Delegated Report

Subject: Melrose Avenue-Review & modification of existing contra-flow cycle lane

MELROSE AVENUE- CONTRA-FLOW CYCLE LANE IMPROVEMENTS

Statutory consultation – 10 February 2022

Scheme drawing Merton Traffic and Highways 'General Layout 2022'

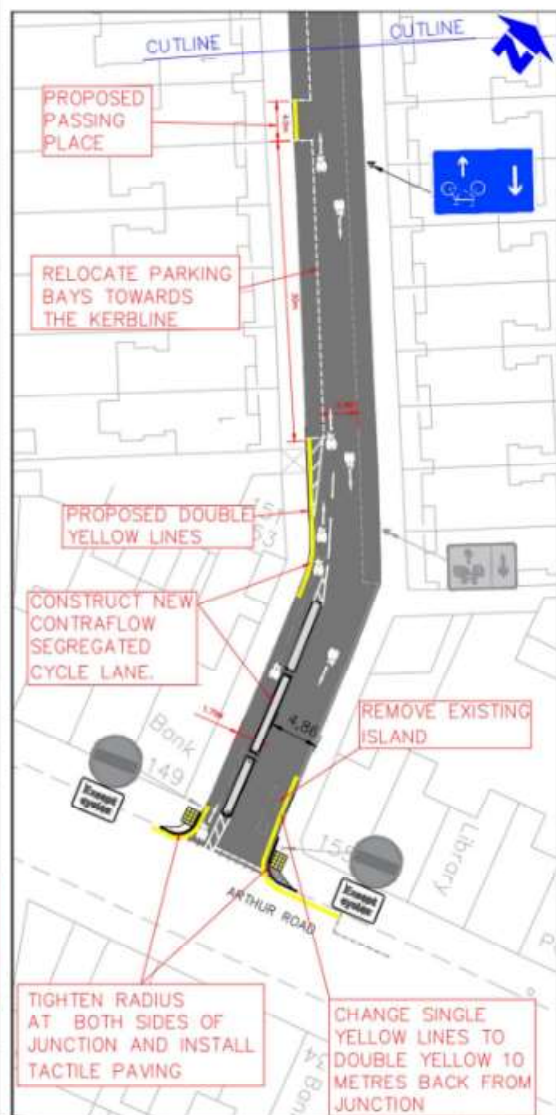
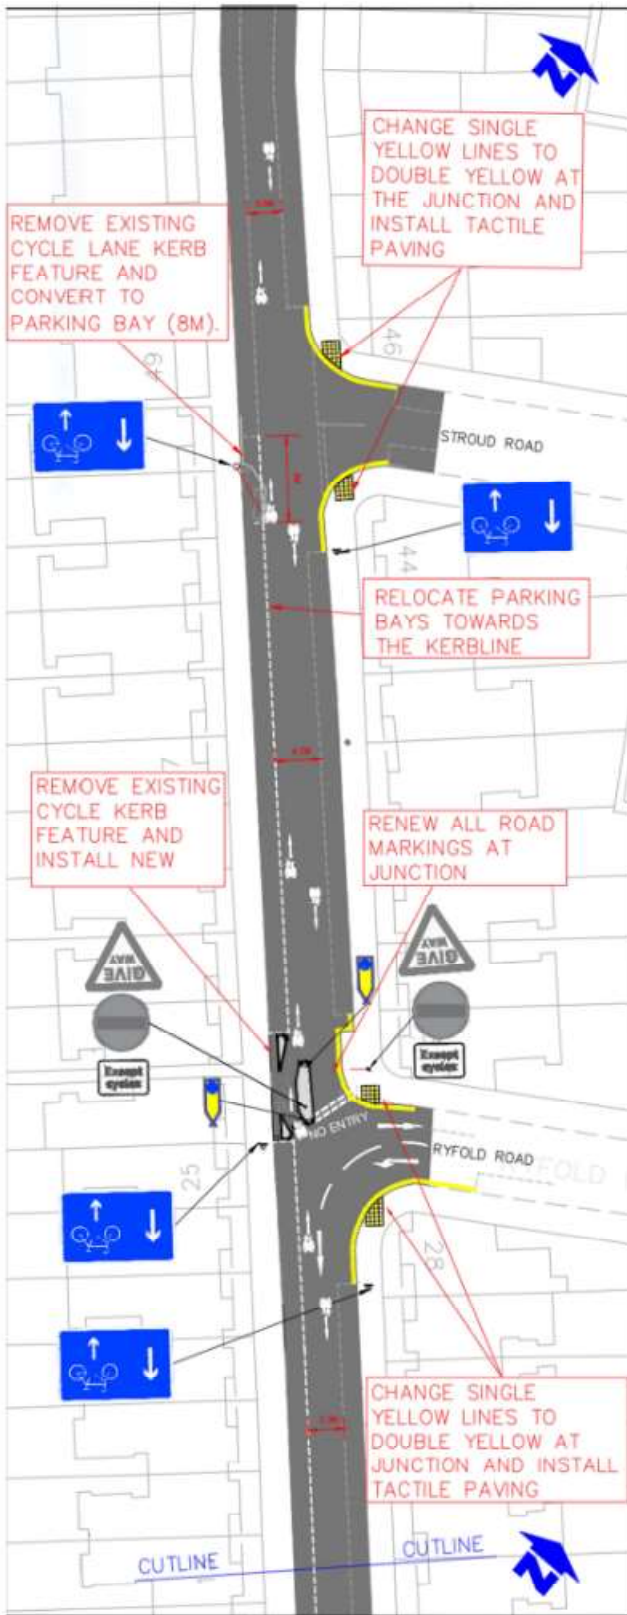
You refer to the plan for the measures you are proposing that "facilitate and safeguard cyclists travelling against the current one-way system".

I cannot see any other measures on your plan that safeguard cyclists:

If the junction is being re-kerbed at the Arthur Rd end then the 4.86m wide space for drivers on the proposal could be much reduced and the footway should be made continuous to provide priority for people walking straight ahead as per this junction below.

We estimate that a minimum of 1 in 10 of the parking places needs to be removed to make these breaks. Without the breaks cyclists will experience extreme discomfort being relentlessly squeezed against the flow of motor vehicles. It is therefore without question that the current proposal is not an improvement and might only

The previous 2019 statement quotes the London Cycling Design Standards (LCDS) 'golden rule': that traffic lanes restricted to dimensions between 3.2 and 3.9 metres should be avoided, because of the discomfort it causes cyclists moving together with motor vehicles. This has now been revised in the latest LCDS to a width between 3.2 and 4 metres. It perhaps can be understood why passing places must be introduced in Melrose Avenue by removing some car parking if contra-flow cycling without a dedicated lane is proposed and why any change to the existing situation without strategic removal of car parking makes cycling considerably more intimidating.
